OFFSITE DOSE CALCULATION MANUAL

REVISION 17

UNITS 2/3 ODCM CHANGES IN REVISION 17

FIGUR 4-1 SONGS 2 & 3 RADIOACTIVE LIQUID WASTE TREATMENT SYSTEMS

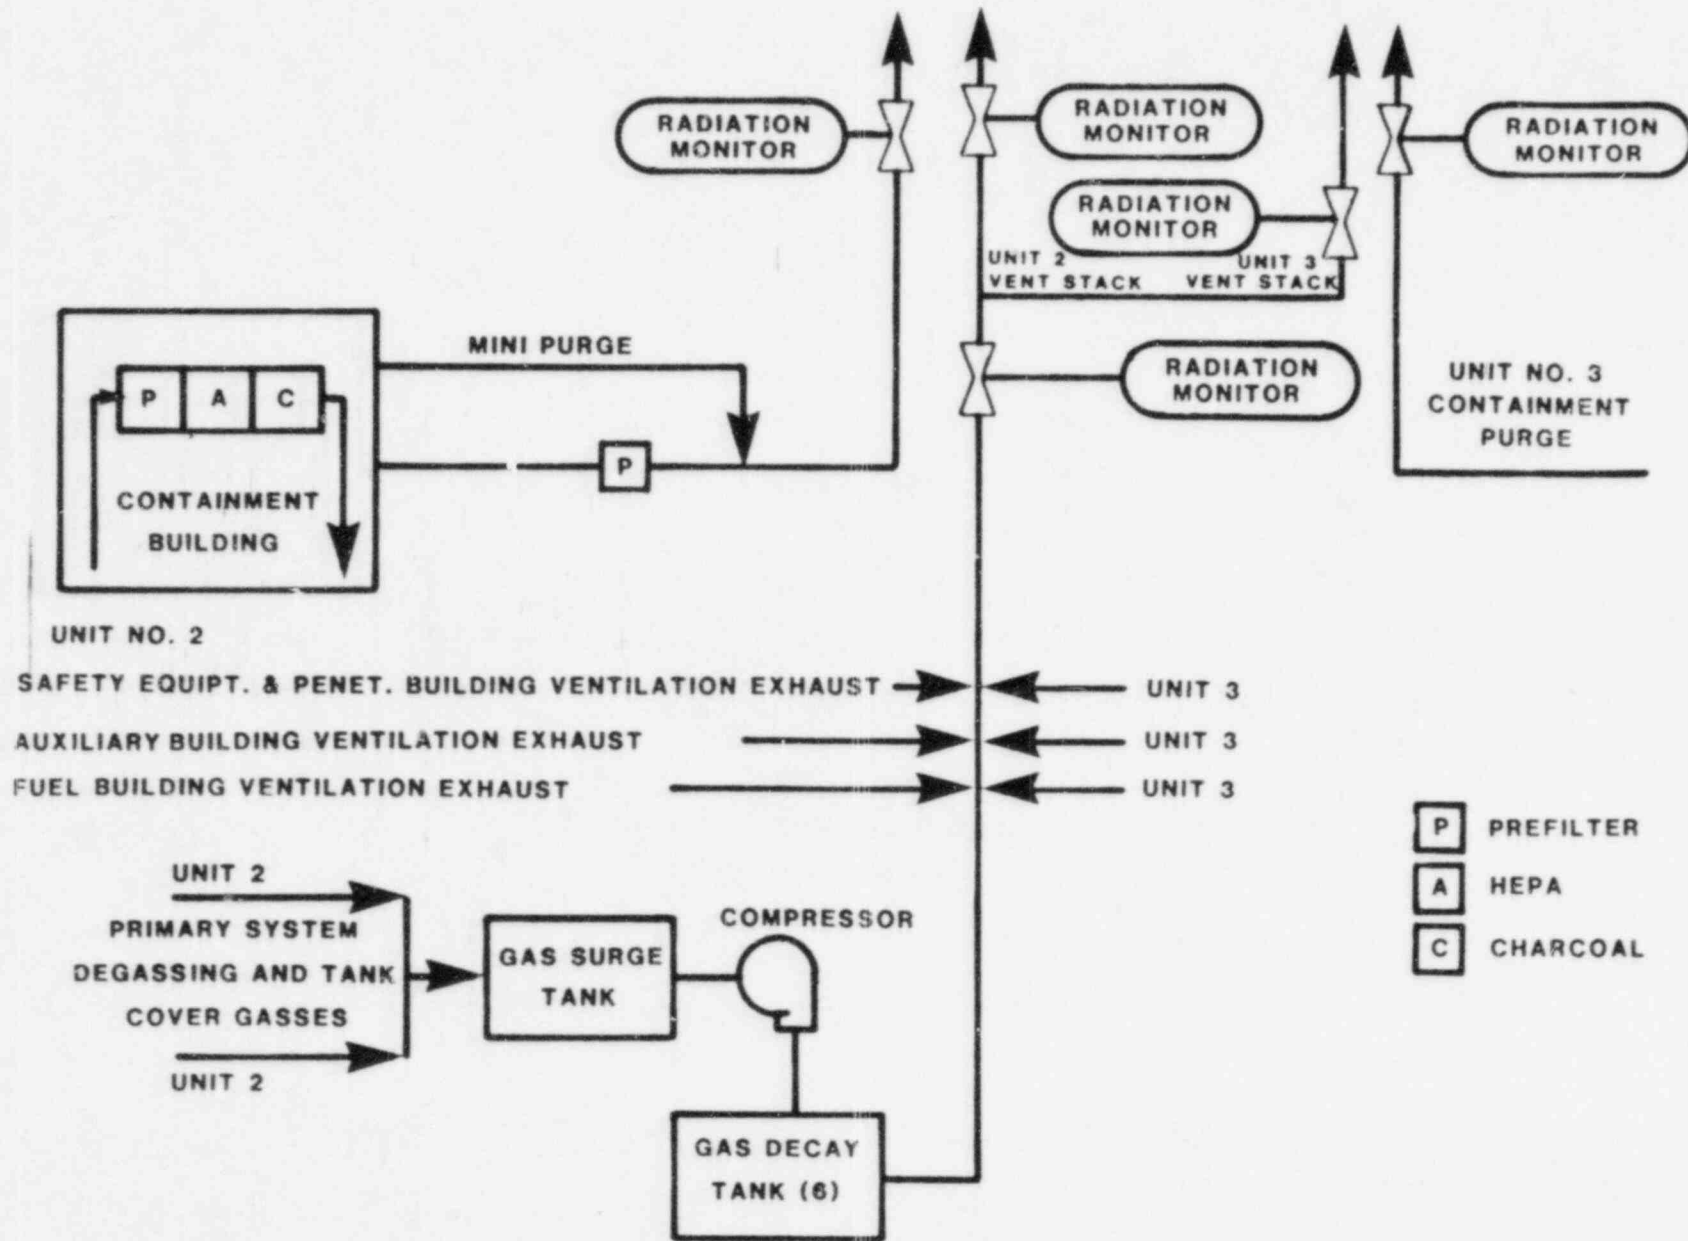
14. Figures 4-1, SONGS 2 and 3 Radioactive Liquid Waste Treatment Systems and 4-2, SONGS 2 and 3 Radioactive Gaseous Waste Treatment System were revised to reflect the "as built" structures and systems. Figure 4-3, Solid Waste Handling, was revised to reflect current Solid Radwaste and Process Control Program procedures.
15. Page 5-9, Table 5-3, This table now has the correct Table number (was incorrectly numbered 5-2).
